City of *OVILLA* City Council

NOTICE OF CITY COUNCIL BRIEFING SESSION 105 S. Cockrell Hill Road, Ovilla, TX 75154

Review and consider the adoption of the 2009 International Building Codes (IBC) with NCTCOG amendments, including local amendments.

**Recommended Amendments to the
2009 International Residential Code**
North Central Texas Council of Governments region

FIGURE R602.6.1
TOP PLATE FRAMING TO ACCOMMODATE PIPING

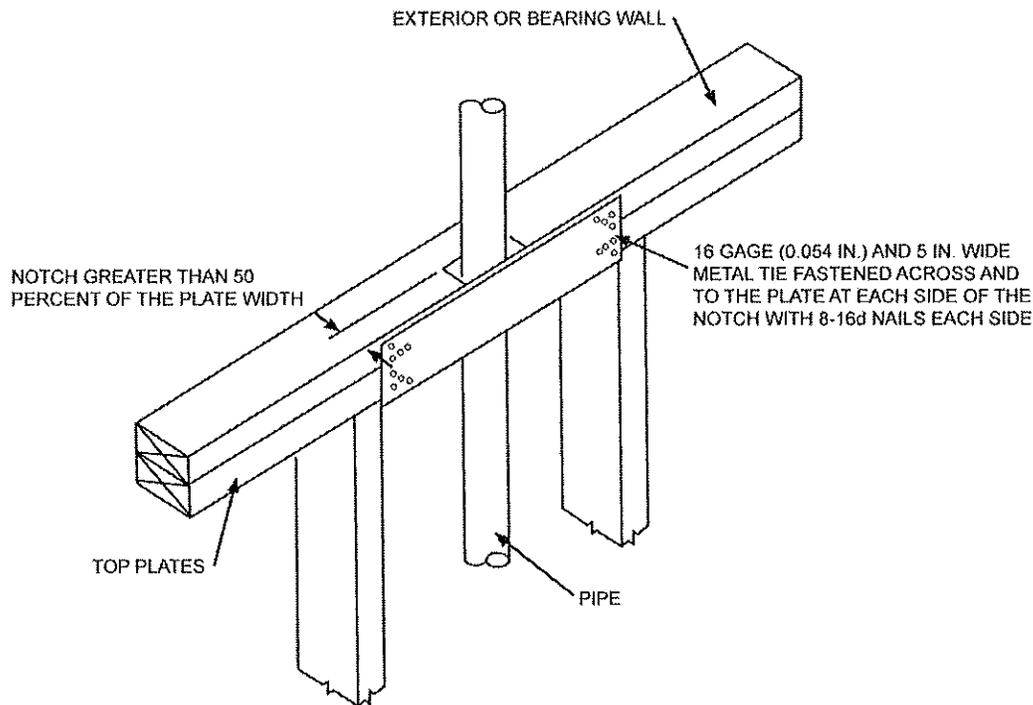
R602.6.1 Drilling and notching of top plate. When piping or ductwork is placed in or partly in an exterior wall or interior load-bearing wall, necessitating cutting, drilling or notching of the top plate by more than 50 percent of its width, a galvanized metal tie not less than 0.054 inch thick (1.37 mm) (16 Ga) and 4 ½ inches (38 mm) 5 inches (127 mm) wide shall be fastened across and to the plate at each side of the opening with not less than eight 10d (0.148 inch diameter) having a minimum length of 1 ½ inches (38 mm) at each side or equivalent. Fasteners will be offset to prevent splitting of the top plate material. The metal tie must extend a minimum of 6 inches past the opening. See figure R602.6.1.

*****Figure R602.6.1; delete the figure and insert the following figure:**

(Reason: reflects regional practice and to comply with P2603.2.1. Also provides additional assurance of maintaining the integrity of the framing by spreading the nailing pattern.)
